DEVELOPMENT NO.:	23004042
APPLICANT:	Michael Fogarty
ADDRESS:	77 MYRTLE RD SEACLIFF SA 5049
NATURE OF DEVELOPMENT:	Single storey dwelling additions with walls located on the southern side boundary, a carport adjacent to the northern side boundary and a verandah to the rear of the dwelling.
ZONING INFORMATION:	<p>Zones:</p> <ul style="list-style-type: none"> • Established Neighbourhood <p>Overlays:</p> <ul style="list-style-type: none"> • Airport Building Heights (Regulated) • Affordable Housing • Character Area • Hazards (Flooding - General) • Prescribed Wells Area • Regulated and Significant Tree • Stormwater Management • Urban Tree Canopy <p>Technical Numeric Variations (TNVs):</p> <ul style="list-style-type: none"> • Minimum Frontage (Minimum frontage for a detached dwelling is 12m; semi-detached dwelling is 12m; row dwelling is 12m; group dwelling is 12m; residential flat building is 12m) • Minimum Site Area (Minimum site area for a detached dwelling is 450 sqm; semi-detached dwelling is 400 sqm; row dwelling is 350 sqm; group dwelling is 350 sqm; residential flat building is 350 sqm) • Maximum Building Height (Levels) (Maximum building height is 1 level)

LODGEMENT DATE:	27 Fe

PO 7.1

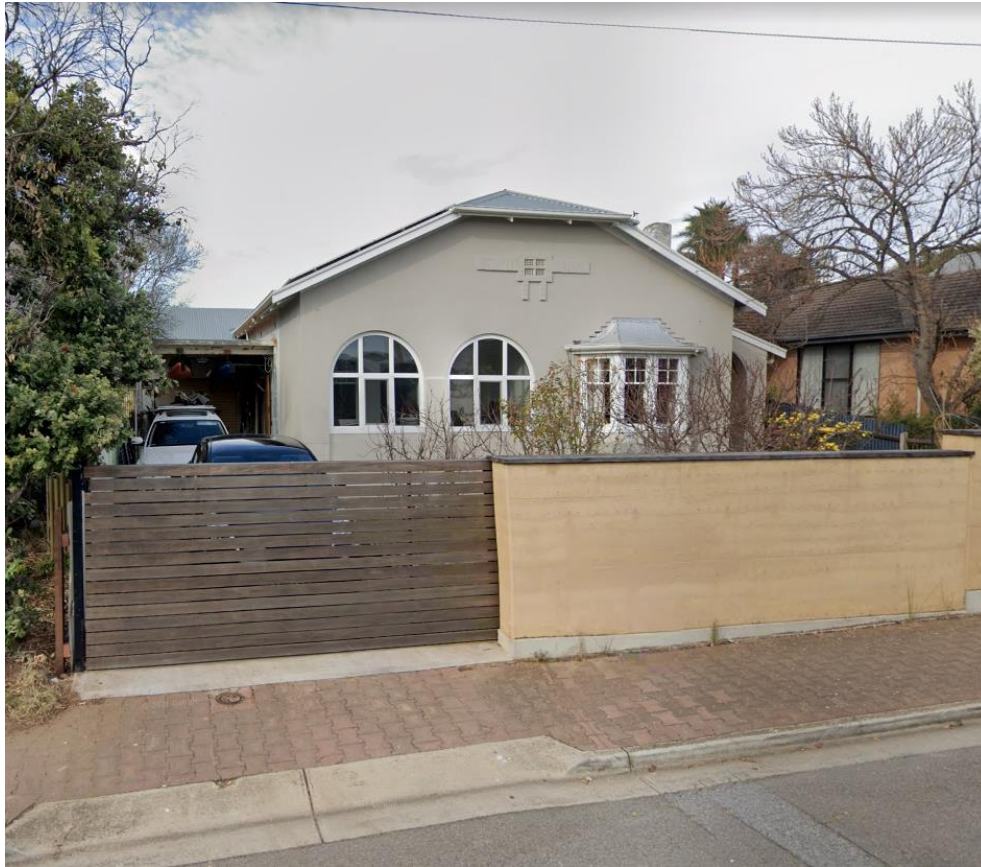
Dwelling boundary walls are limited in height and length to manage visual and overshadowing impacts on adjoining properties.

Visual impacts are considered to be negligible as the wall is adjacent to the front driveway of the southern neighbouring dwelling. The images below show a close-up aerial of the site and the neighbouring dwelling as well as streetscape photo of the southern dwelling.

The boundary wall will cast shadow over the existing driveway and will not impact any areas of private open space or north-facing windows. Therefore PO 7.1 is considered to be satisfied.
